Re: I-90 Allston Interchange Project, Boston, MA
Draft Environmental Impact Report ("DEIR"), EEA No. 15278

We at A Better City are pleased to submit the following key comments on the above referenced project. We support the selection of Variation "3K-ABC" (hereinafter "All At-Grade") as the Preferred Alternative for the Allston I-90 Interchange project, and that it be used as the base for further development of the design. We appreciate that this base could be amended and enhanced to more broadly address additional goals of various stakeholders, and we urge MEPA to require that MassDOT go forward with a robust public Task Force process with continued public participation to collaboratively advance design of the All At-Grade and select it as the Preferred Alternative in the Final Environmental Impact Report.

River Park on the Charles

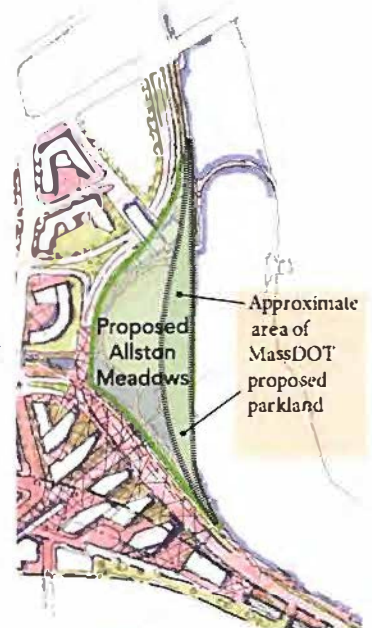
In this Vision, a new 6-acre park node in Allston, (Allston Meadows), coupled with Magazine Beach across the Charles, engages the river with its neighborhoods in new ways, both on the water and along its banks, creating a new central, destination river park sited in both Cambridge and Allston.

As shown, Allston Meadows could include a large grassy field for picnics, events and recreation; a quiet cove at the mouth of the reopened and restored Salt Creek providing additional turning space for rowing events; a performance ring with a grand staircase/seating to West Station Plaza, a year-round restaurant/activity space at the water's edge, a ferry landing with docks, a segment of a replanted and expanded Allston Esplanade, and convenient pedestrian connections from all of the above to Boston University and Commonwealth Avenue.

Grand Junction Bridge today (above) and, in the future (below) incorporating park paths. In this view, the BU Belvedere sits atop the realigned Turn Pike (West bound)

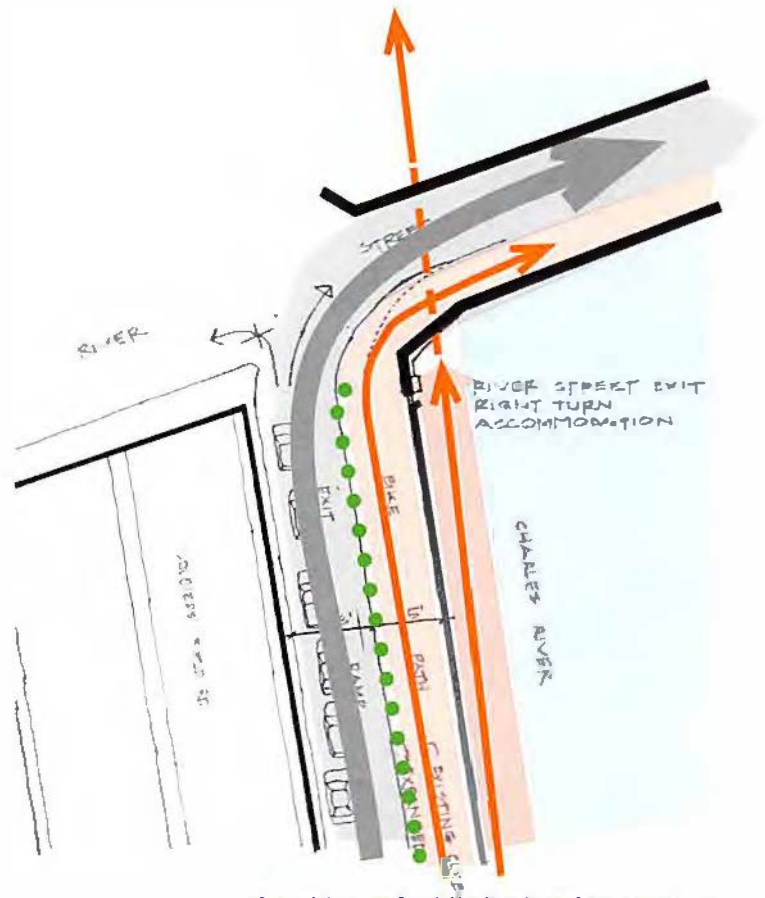
1. It will upgrade rail service into Cambridge, as a potential rail link from Cambridge to North Station.
2. The existing bridge is old, poorly maintained and in need of significant repair.
3. Both its horizontal and vertical alignments will likely need to shift in order to become a significant new public transitway into Cambridge and North Station.
4. The bridge's present abutments prohibit development of pathways under the BU Bridge that could efficiently extend the Boston Esplanade pathway system upriver along the extensive Paul Dudley White Bikeway that runs the length of the Basin.
5. The reconstruction can eliminate a dangerous 'kink' in the path system by removing the existing narrow 'over-water' pedestrian/bicycle wooden bridge, with its poor sightlines and channel restrictions.

6. Removal of the wooden bridge would make it easier for boats to navigate the BU pier abutments. This should be a major priority for both the DCR and boaters.

Provide a safer bike/pedestrian way, one right-turn-only lane and a new bike ped connection under the River Street Bridge

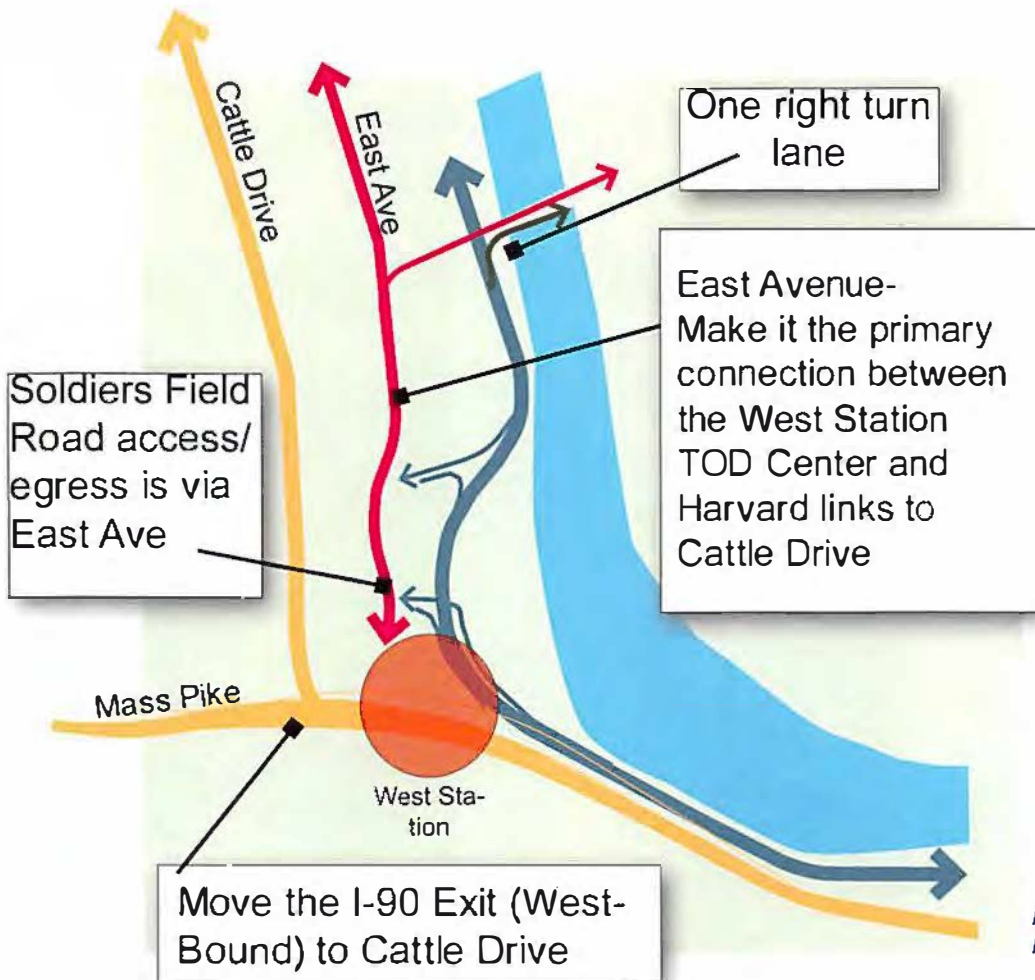
This is one of the Allston Esplanade's most unpleasant and unsafe stretches.

While MassDOT's current recommendation to remove the west-bound off-ramp altogether appeals to bikers and park lovers, this is also a major access point for drivers into Cambridge. Two improvements could ease this situation and allow a single right-turn-only off-ramp to remain:

1. The Charles River Conservancy proposes a bike/pedestrian passage under River Street. Most bikers and pedestrians would then be safely separated from right turning vehicular traffic, thus facilitating these right turn movements for motorists. Since this bridge is in poor repair and in need of reconstruction, this project should dovetail closely with MassDOT's planned Allston I-90 improvements.
